Second Review of “The Pléiades Glacier Observatory: high resolution digital elevation models and ortho-imagery to monitor glacier change” by Berthier et al.

David Shean

August 11, 2024

The PGO sample I downloaded (Makalu_ASE_2018-10-16_0500119_2023-10-23_0500156) illustrates the problem...

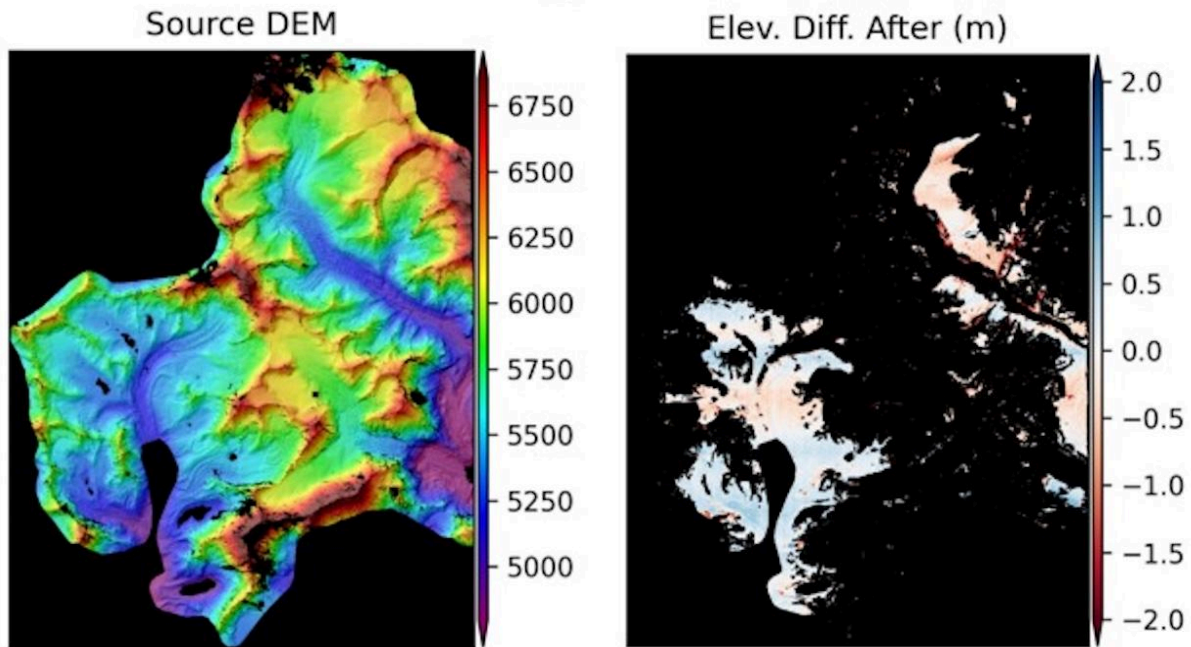
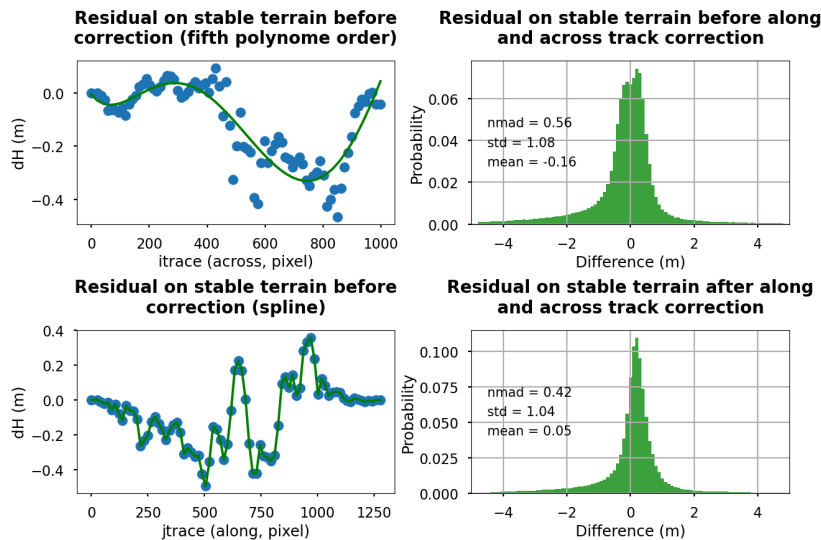
Based on the text, it sounds like this 5th order polynomial cross-track correction is performed first, then the spline along-track correction is performed second. **The order of these corrections is important, so if this is not the case, please clearly state the order in the text.** The order stated in the PGO paper (cross-track then along-track) is different than Gardelle et al (2013) "Then, we compute the elevation differences along and across the satellite track on stable areas and when necessary correct the bias using a 5th order polynomial fit."

The right plot shows the non-uniform, anisotropic distribution of “stable” surfaces, and the clear residual along-track jitter artifacts over these surfaces. By first computing a cross-track correction, the non-uniform spatial distribution of the static control surfaces leads to preferential sampling of the jitter bias (which dominates the residuals), so the area to the west appears to have slightly positive bias, and the area to the east appears to have negative bias. Fitting the cross-track correction to these residuals, before the along-track jitter correction, biases some columns by over 0.3 m in this case, which will propagate to all glacier surfaces in those columns.

The along-track jitter correction should be performed first, as this captures most of the observed residual variability. I maintain that lower-order polynomials (planar, at most 2nd order) are sufficient to capture expected cross-track artifacts for linescan stereo sensors like Pleiades (assuming the detector array geometry is good, which it is for PHR1A and 1B).

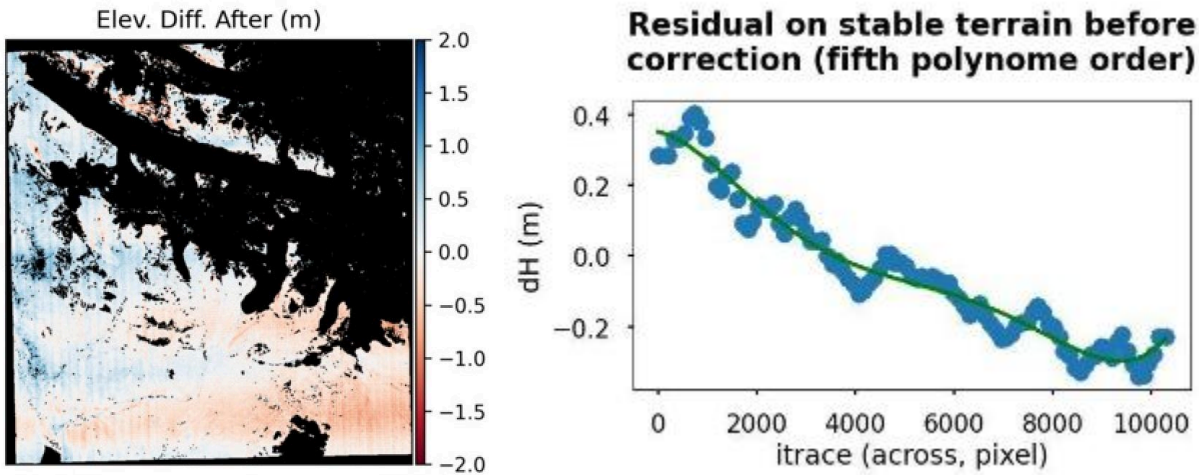
Following along-track correction, the Gulkana residuals (below, mentioned in the response doc) could be modeled with a linear correction.

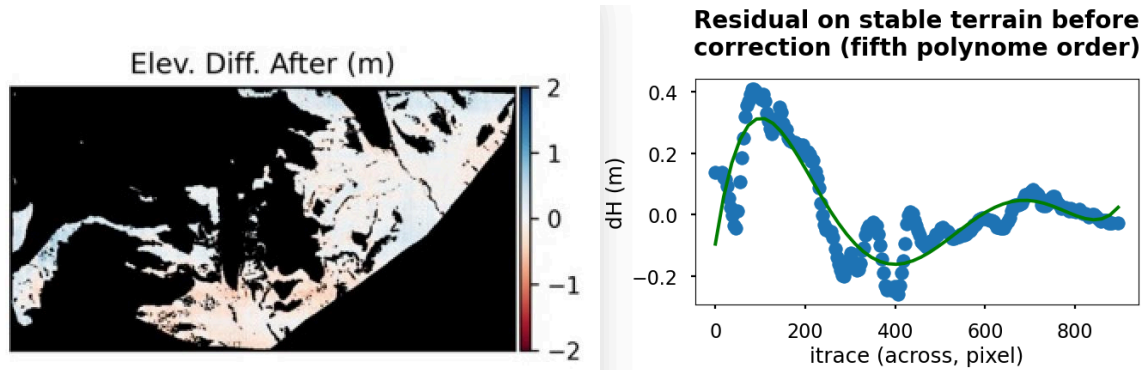
The Olsen residuals (also cited in the response doc) suffer from the same issues as Makalu above, with limited stable terrain, and non-uniform sampling of the jitter artifacts leading to apparent cross-track artifacts. The current PGO correction is unnecessarily introducing +/-0.2 to 0.3 m bias over adjacent glaciers.

Fig 7 - NMAD for BM and SGM compared to lidar for Hellstugubreen

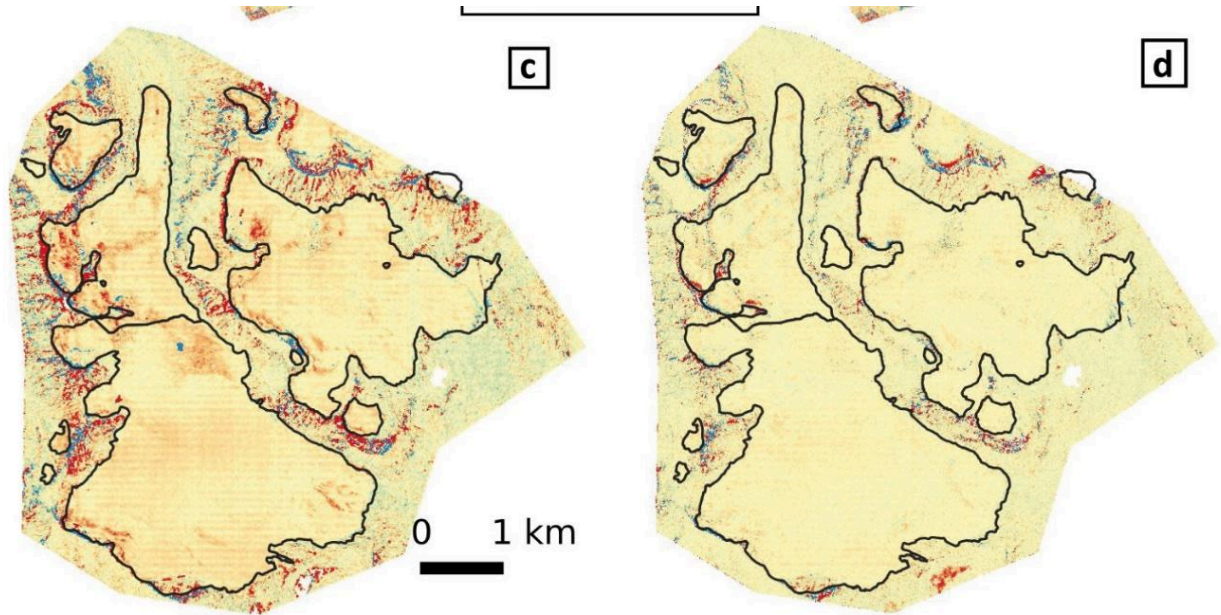
I'm a little surprised by the observed differences between c and d if the only difference is the input PGO DEM using BM (c) vs. SGM (d). This potentially indicates that the independent co-registration approach (co-registering BM to lidar and independently co-registering SGM to lidar) is introducing bias that could be incorrectly interpreted as due to the correlation approach (or terrain properties). **We observe many local artefacts (Figure 7). However the bias (see column "Median Dh on glac**

I think the authors misunderstood my earlier comment. It appears that there is larger residual horizontal geolocation error in the BM product compared to the SGM product, likely introduced during the independent co-registration process for each. Please check the translation vectors for the dh maps used to produce 7c and 7d - I can't do this because the products involving lidar data are not available (which is fine, but limits reproducibility).

I'm having a hard time understanding how the on-glacier NMAD values in Table 3 for the Hellstugubreen **BM** DEM (0.12 m, Fig 7c) is lower than the on-glacier NMAD for the

Hellstugubreen **SGM** DEM (0.15 m, Fig 7d). Just looking at these difference maps (with identical color ramp), there appears to be more spread in the BM dh product than the SGM dh product (reproduced above for clarity). I'm wondering if there was potentially a mistake in the analysis/plotting code or labeling in the figure? Maybe double-check, and if necessary, modify the statement on linked 364-366:
